Subject: Duke Energy Carolinas, LLC
McGuire Nuclear Station, Units 1 and 2
Docket Nos. 50-369, 50-370
Emergency Plan, Revision 14-5

Please find attached Revision 14-5 to the McGuire Nuclear Station Emergency Plan. This revision is submitted in accordance with the requirements of 10 CFR 50.54(q) and does not result in a reduction in the effectiveness of the Emergency Plan or the Emergency Plan Implementing Procedures.

DUKE ENERGY
McGUIRE NUCLEAR SITE
EMERGENCY PLAN

REVISION 14-5: December, 2014

Figure J-1
1 of 3
Guidance for Offsite Protective Actions

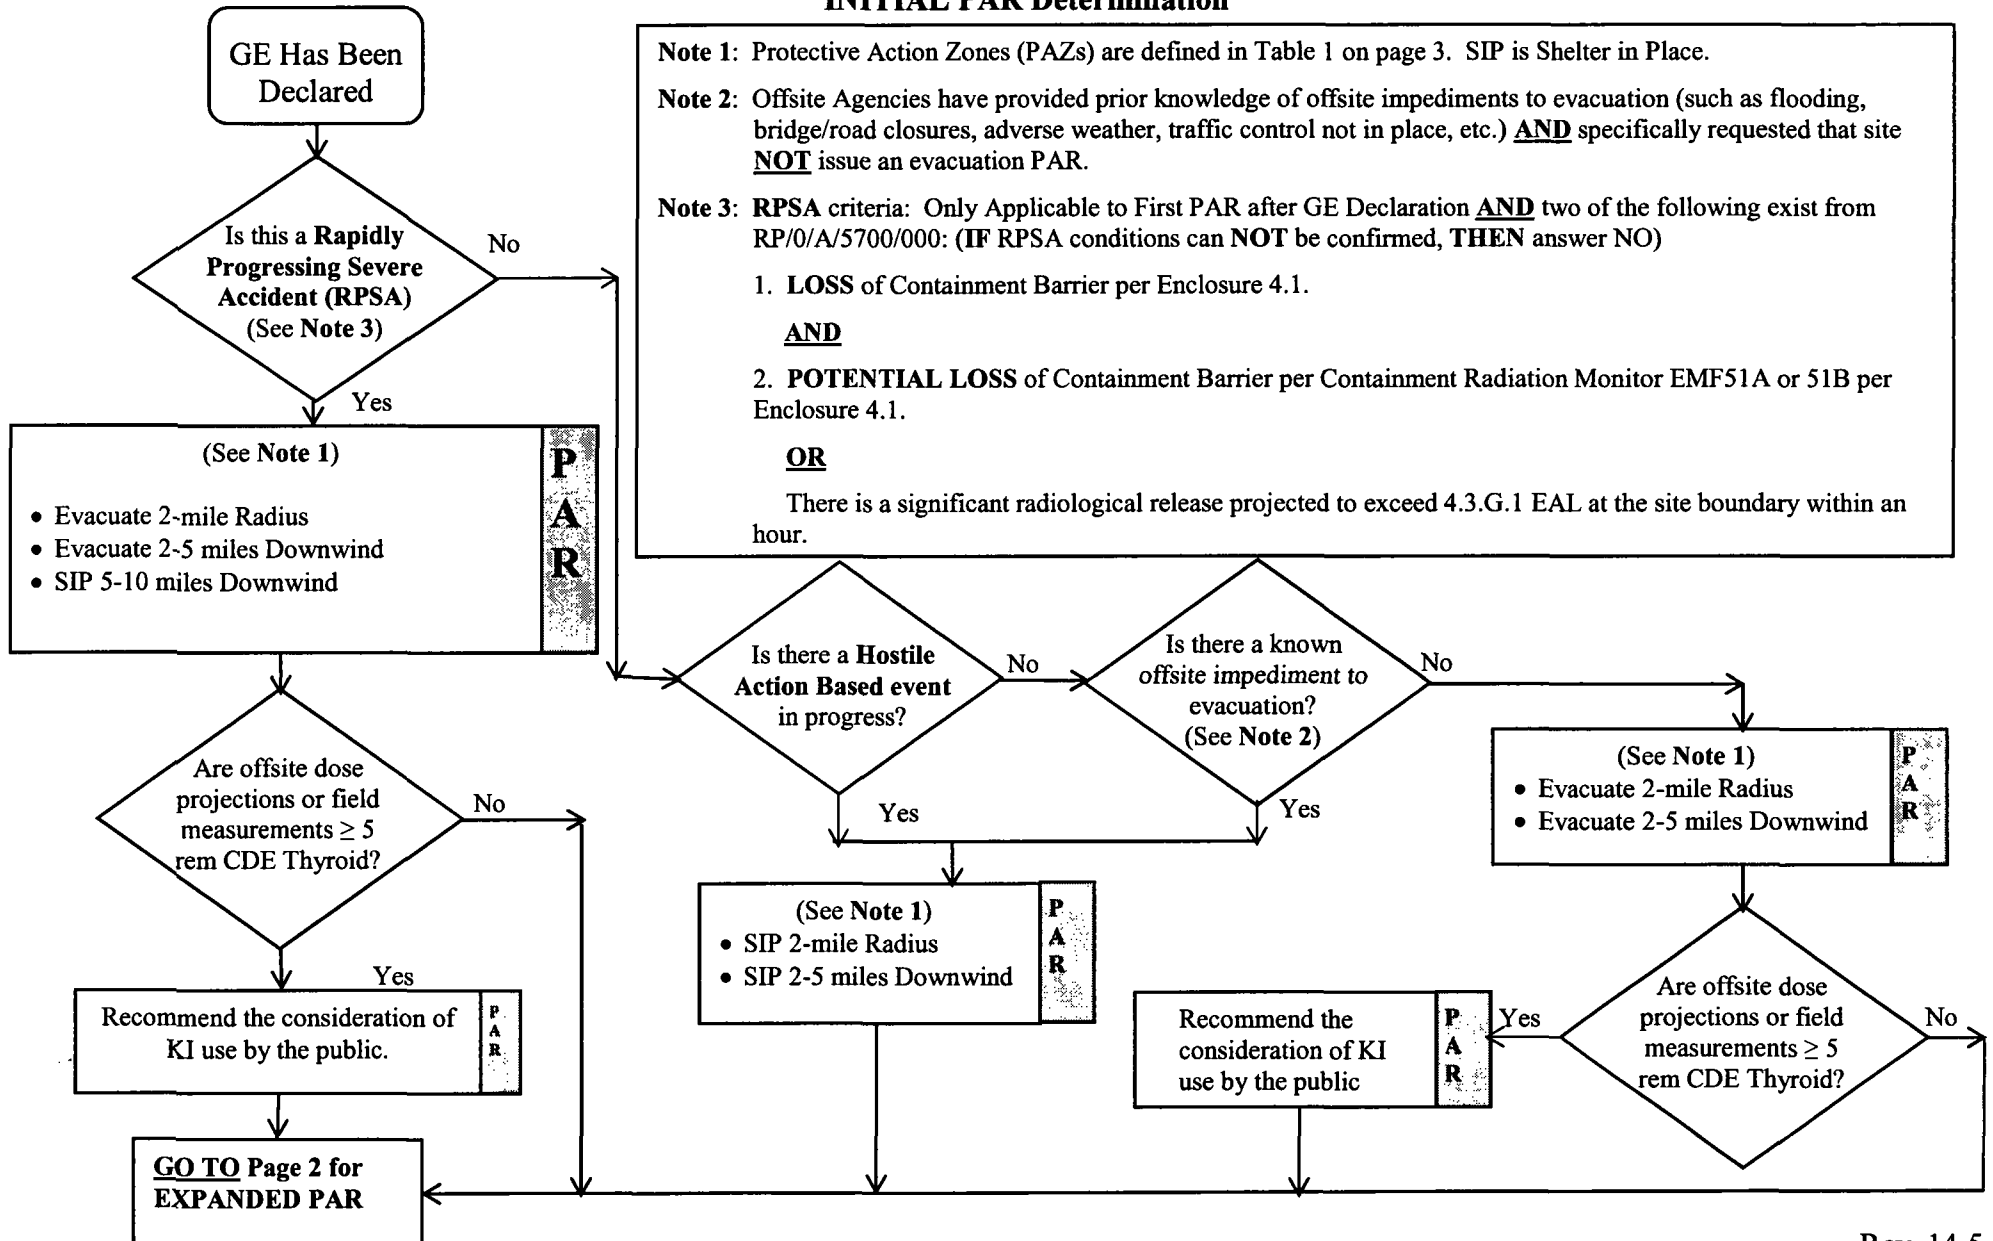
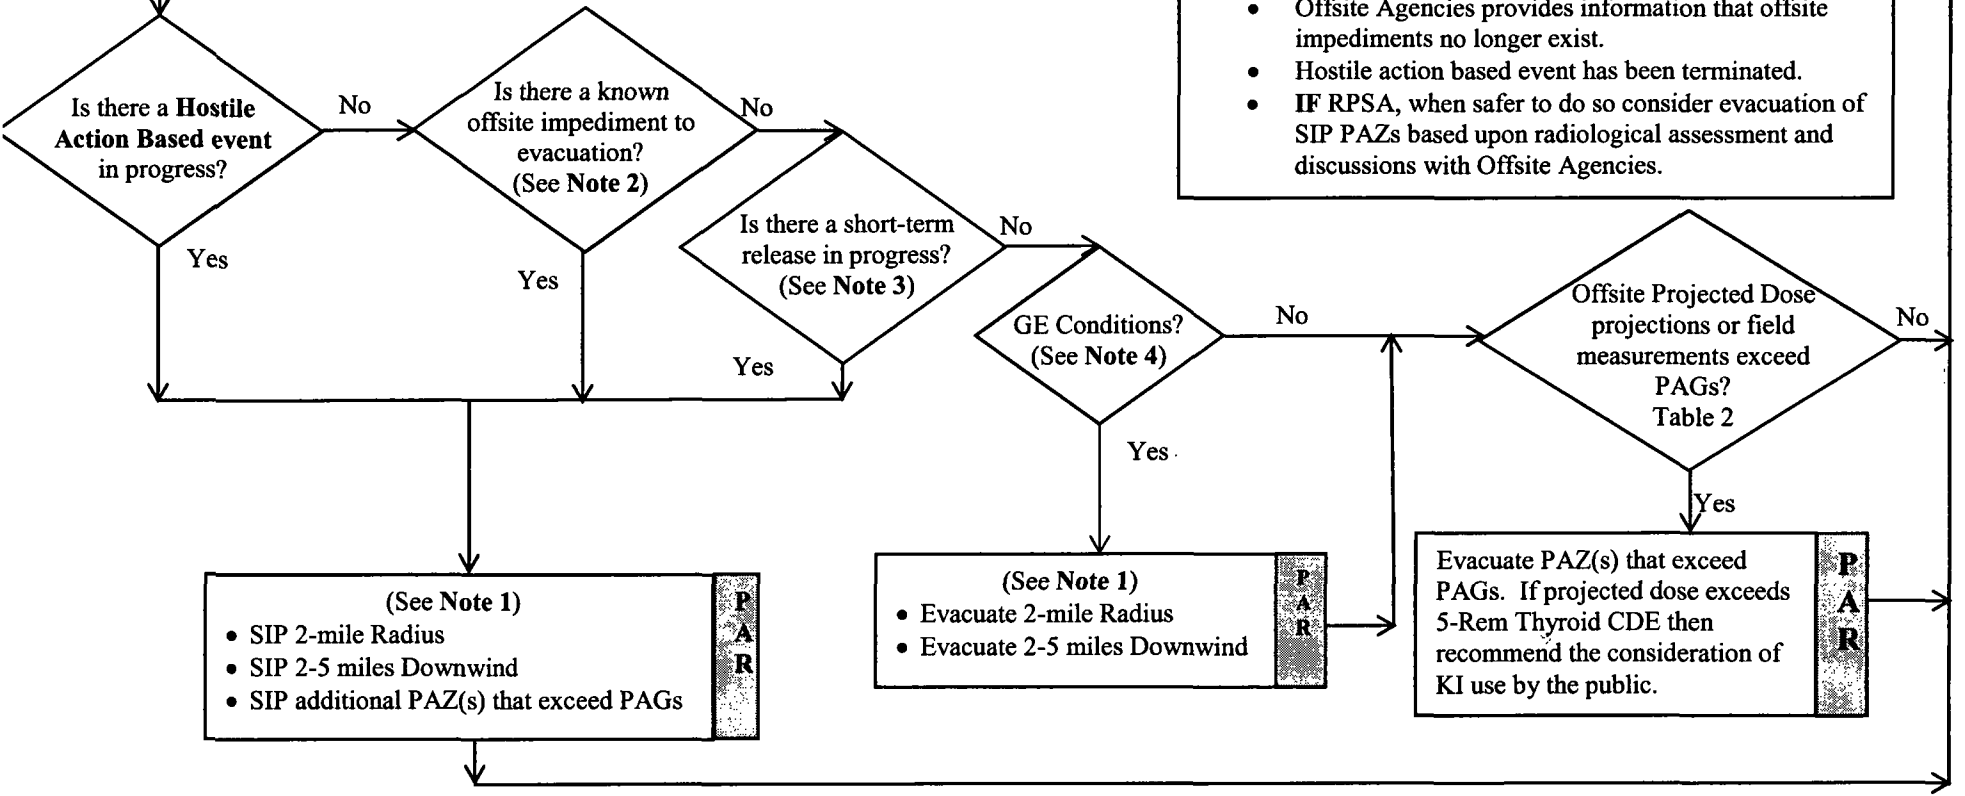
**§50.54(q) Screening Evaluation Form Activity Description and References:
MNS Emergency Plan Section J - Figure J-1, Offsite Protective Actions
rev 14-5 December 2014**

MNS EPlan Figure J-3 provides data to evacuate a 5 mile radius verses 2 mile radius and Keyhole to 5 miles. The greatest time for ETE for a five mile radius is 5 hours and 45 minutes. The greatest time for ETE for a 2 mile radius and Keyhole to 5 miles is 3 hours and 10 minutes excluding a road impediment.
